KUM & GO GAS & C-STORE

MAJOR SITE DEVELOPMENT PLAN

2232 - EL PASO, COLORADO
SECURITY BLVD. AND MAIN ST.
GRADING PLAN

PCD FILE NO. PPR-2225

2232 - EL PASO, COLORADO
SECURITY BLVD. AND MAIN ST.
EROSION AND STORMWATER CONTROL PLAN - INTERIM

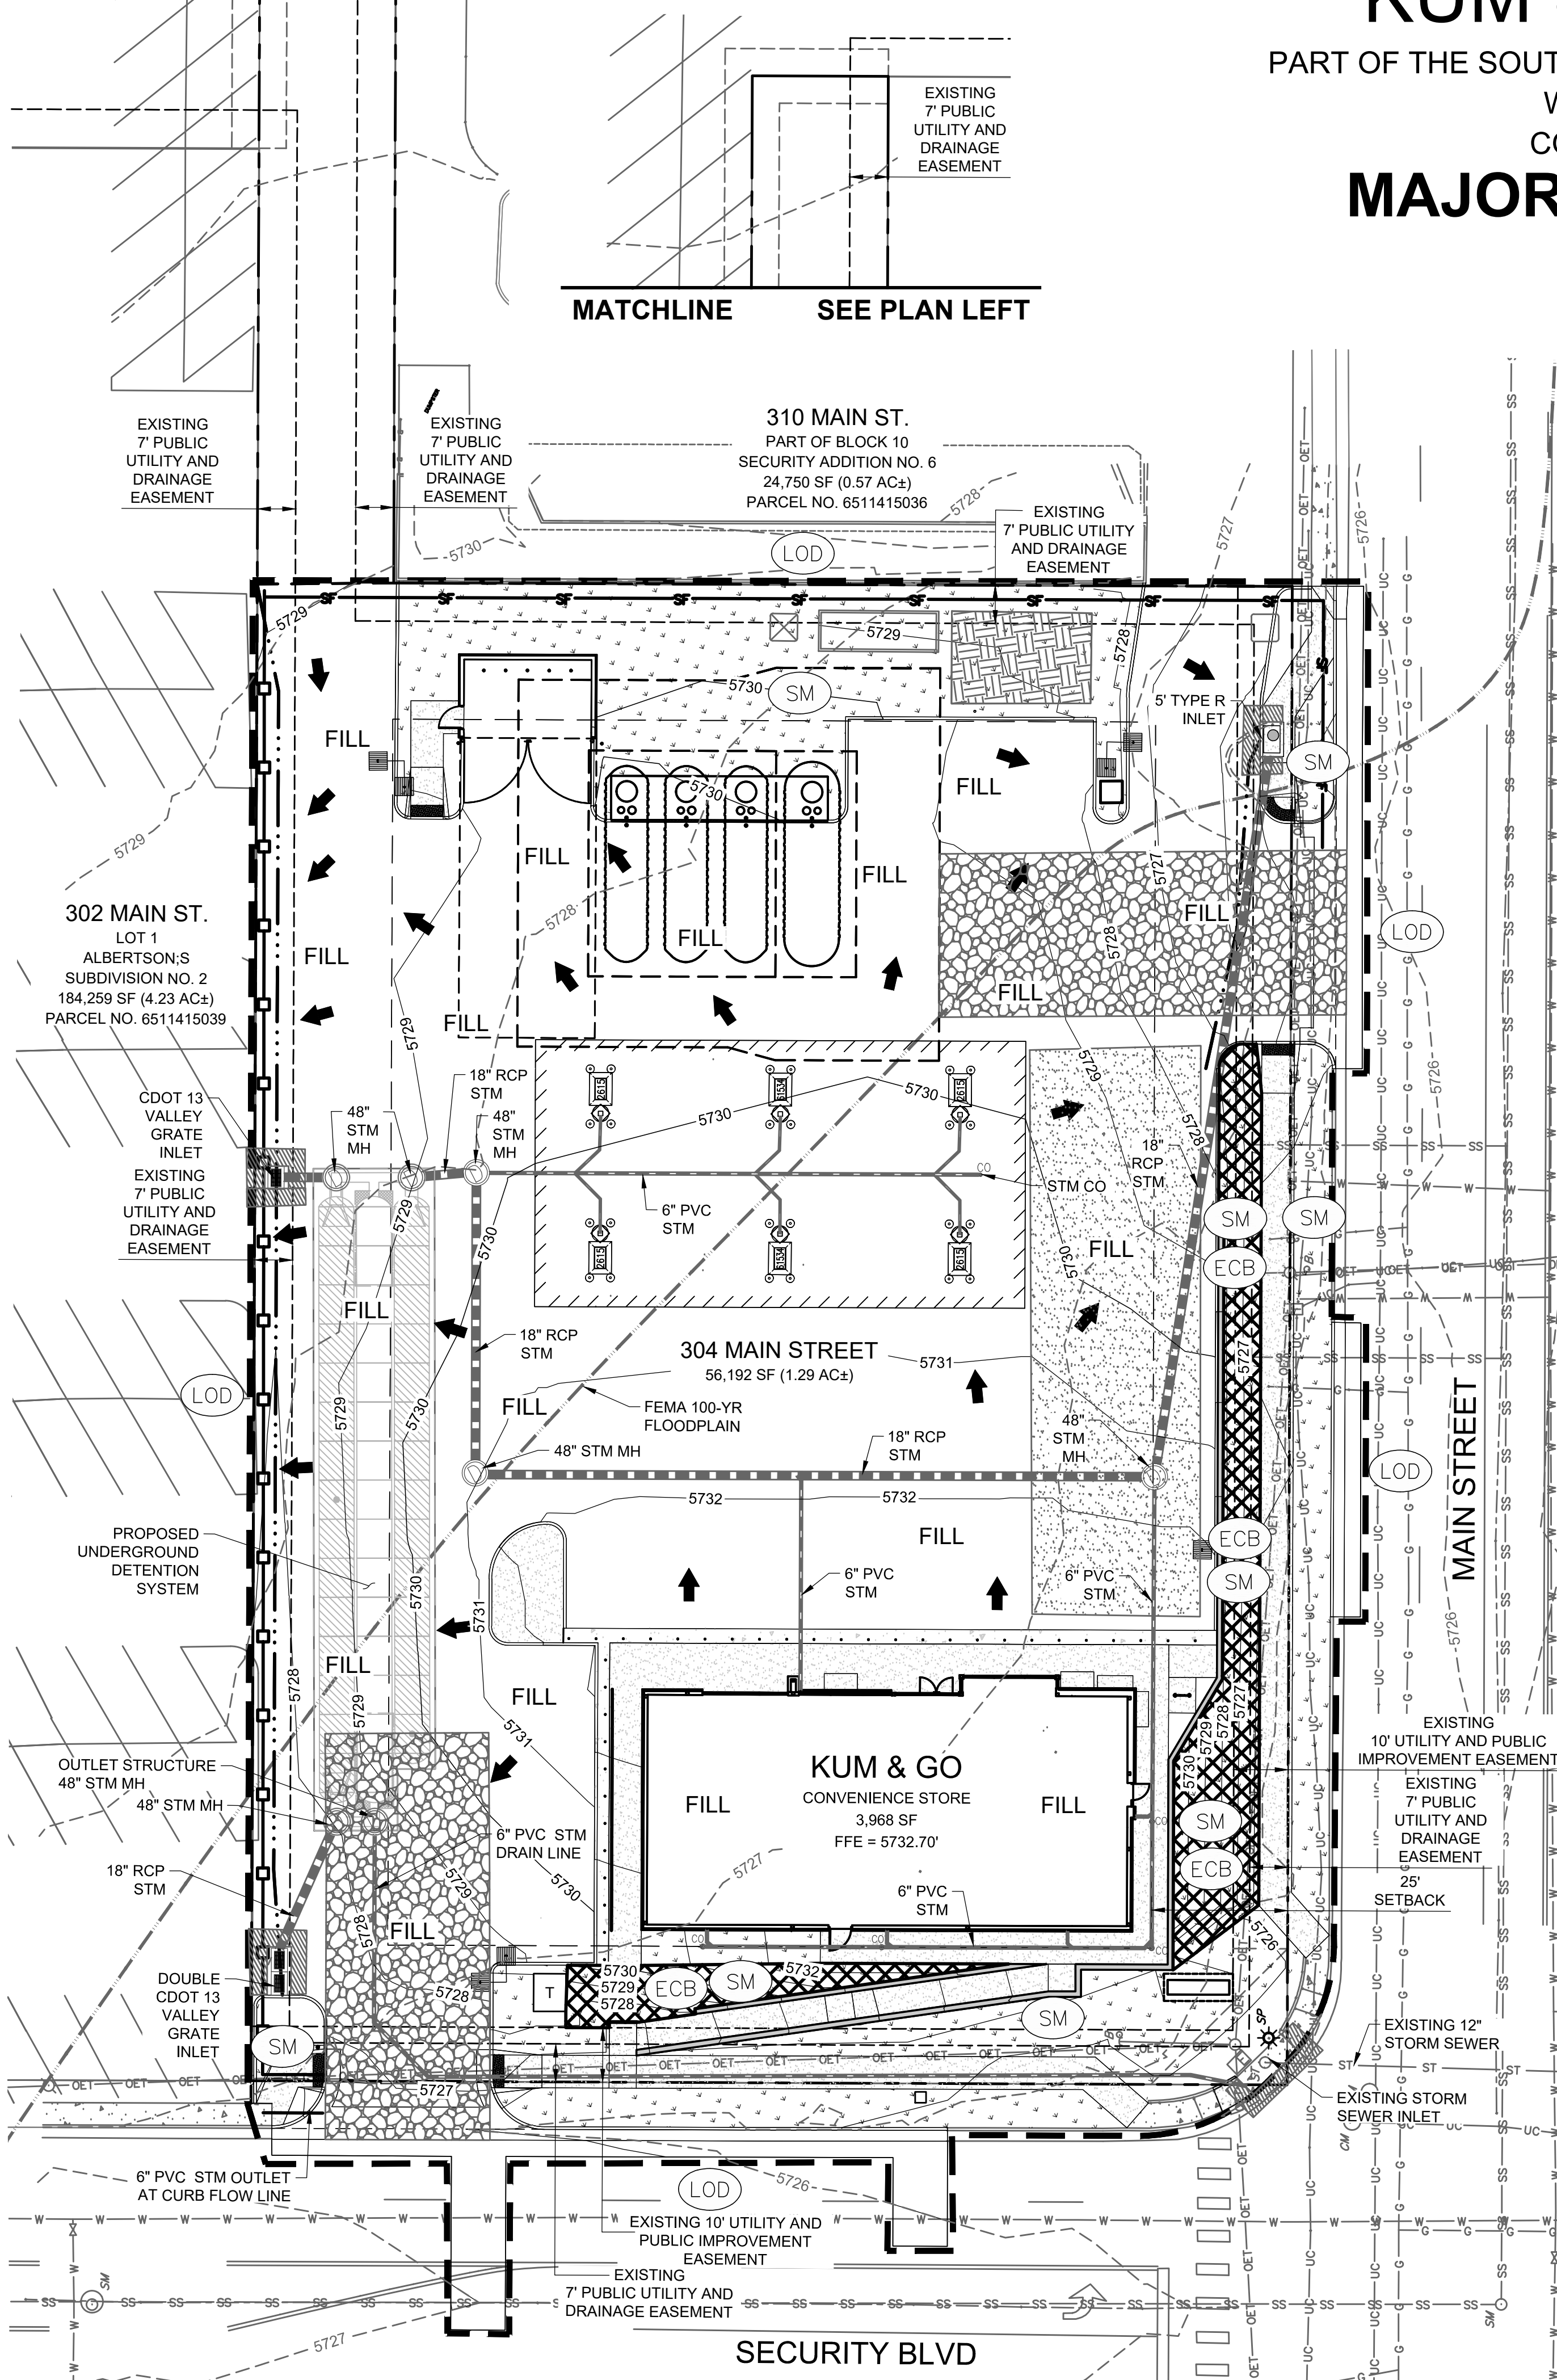
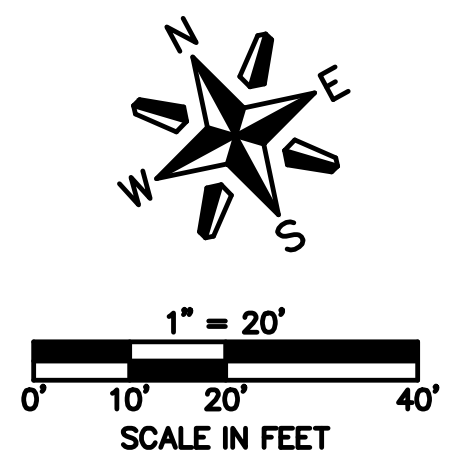
add 10' length as done on previous sheet.

Show and label concrete pan.
ADDED PER COMMENT.

remove this text, outlet piping has changed.

ADDED PER COMMENT

2232 - EL PASO, COLORADO
SECURITY BLVD. AND MAIN ST.
STORM SEWER PLAN

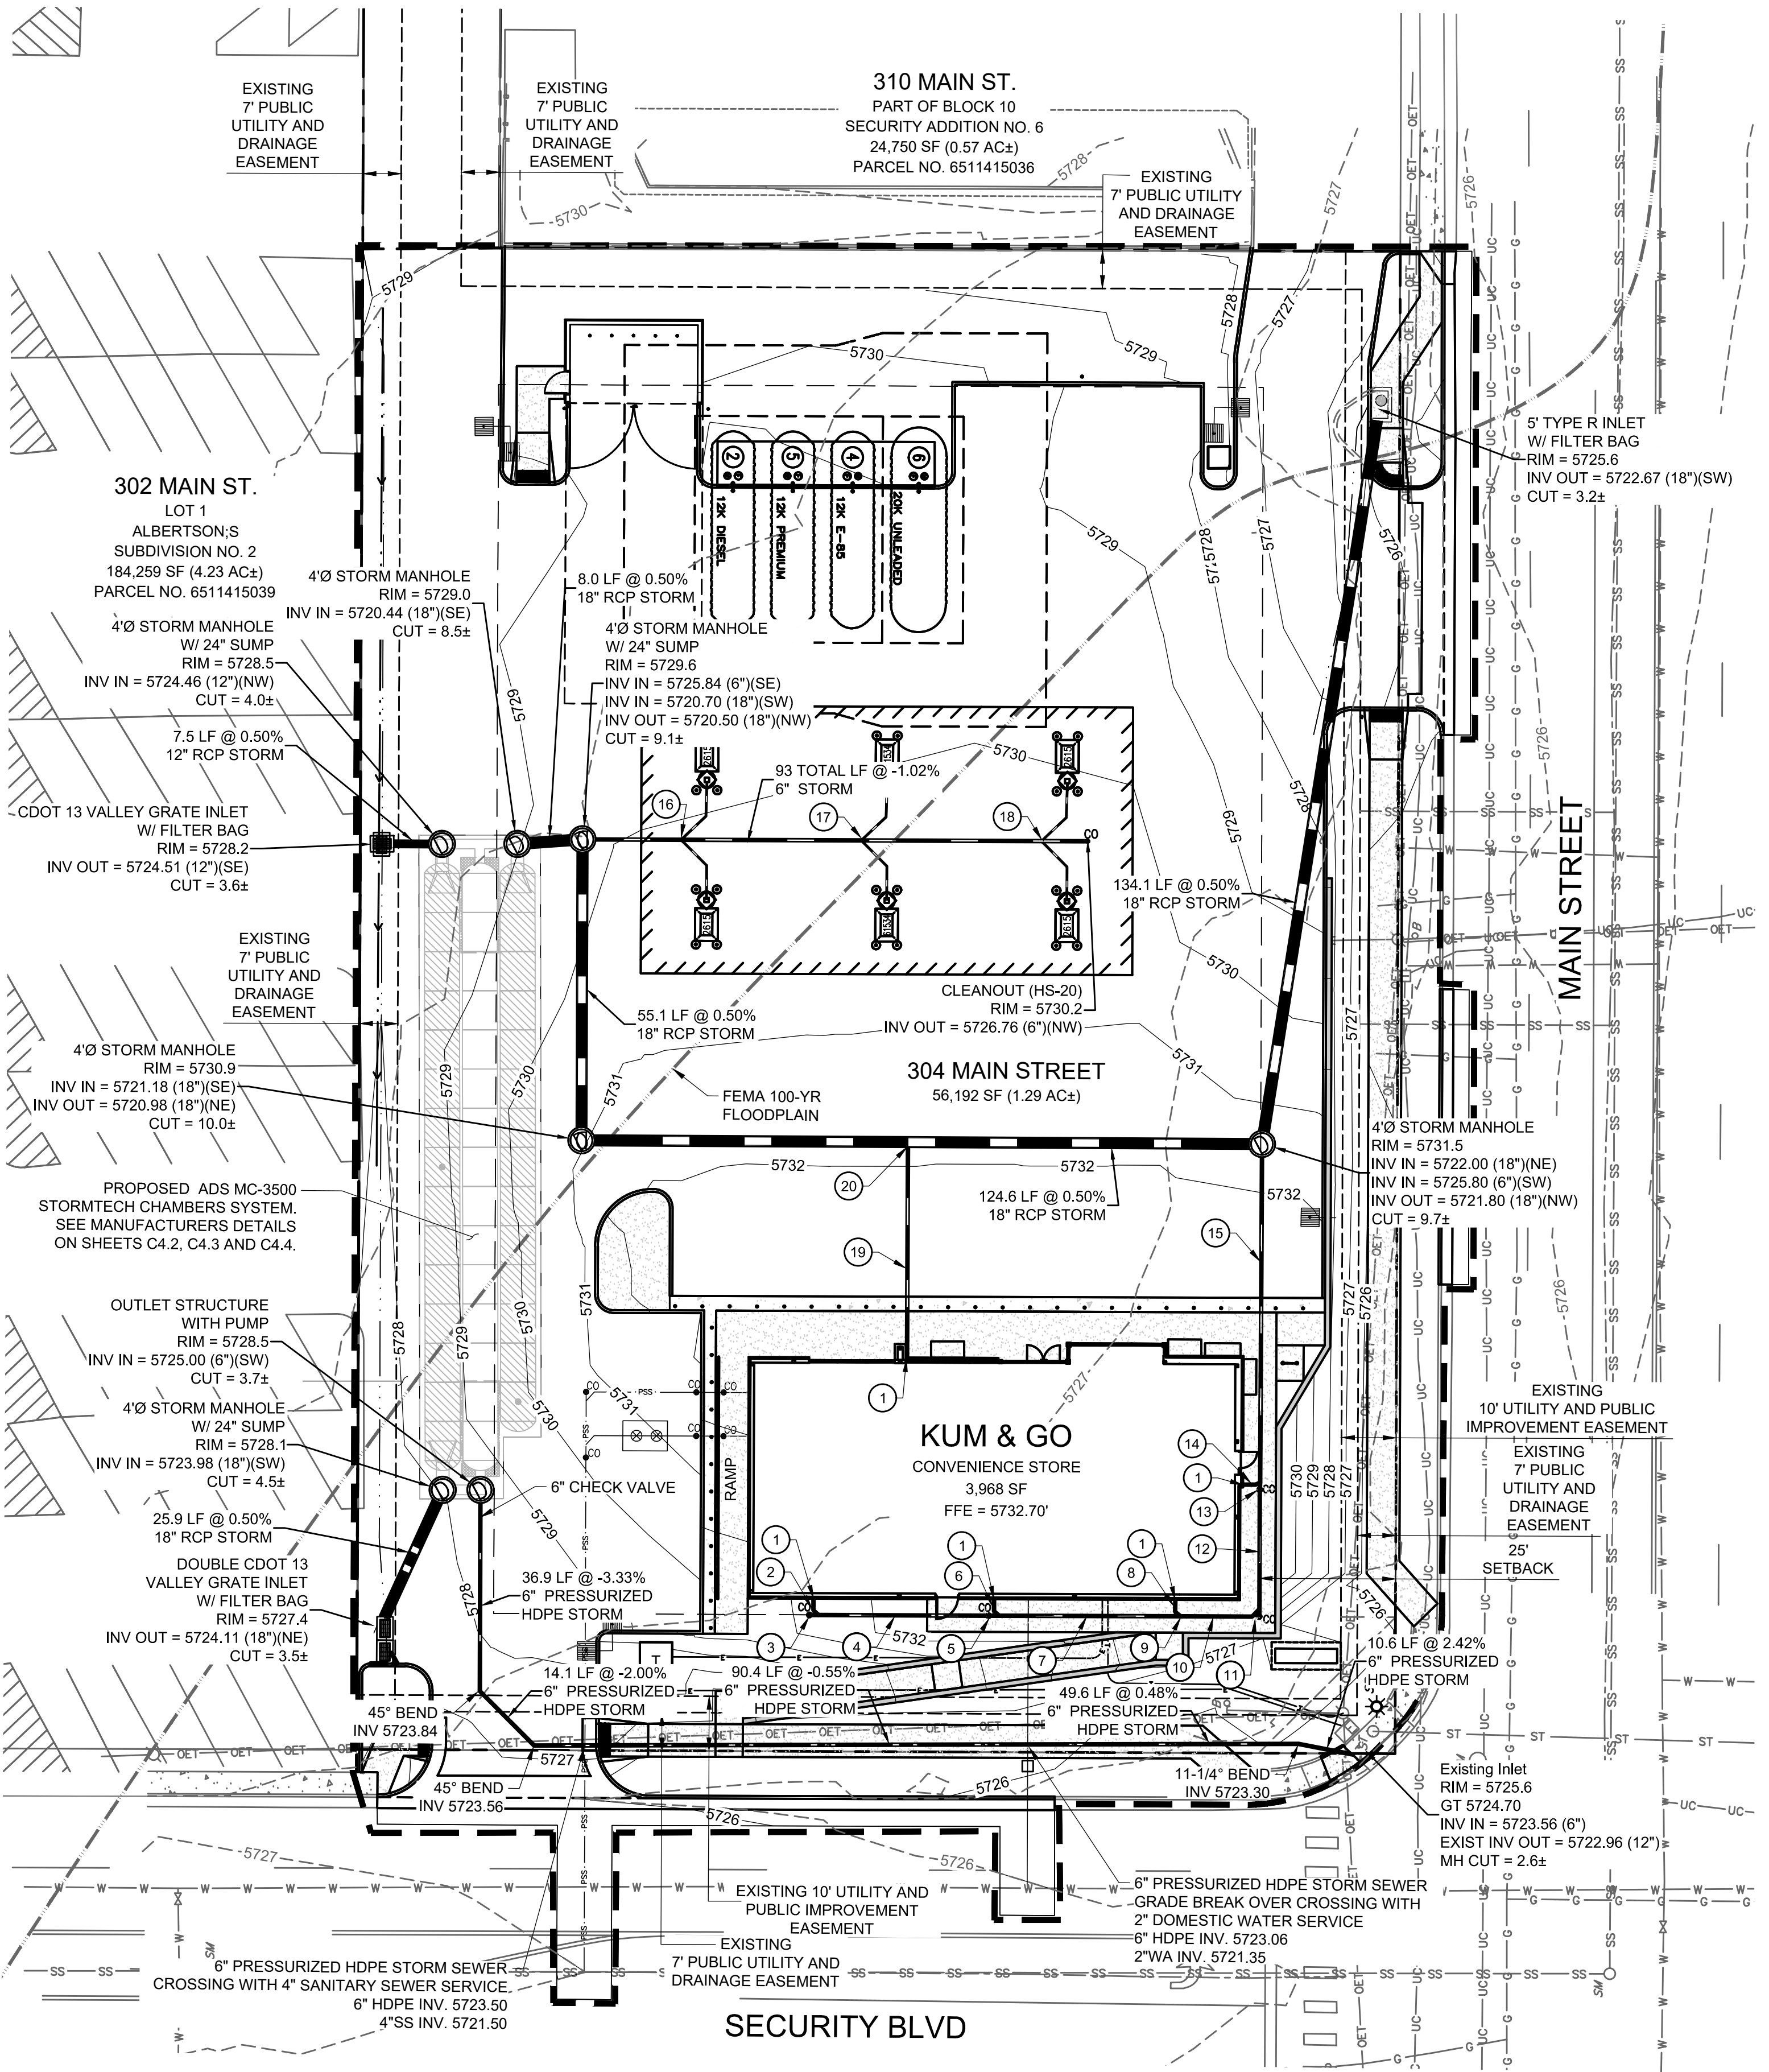
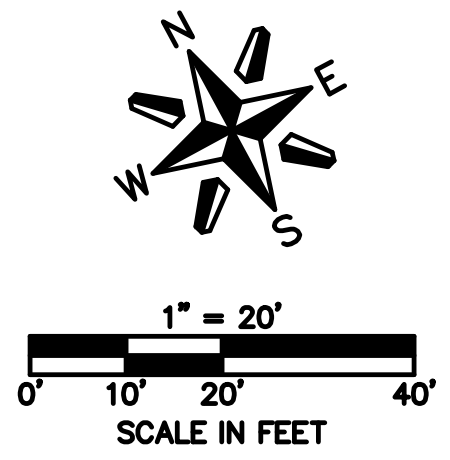
Please remove pdf pages 12-15 from this document. No need to duplicate those here when they are in the SDP doc. Pages 1-11 above are all that is needed for this separate GEC Plan doc.

SHEETS HAVE BEEN REMOVED PER COMMENT
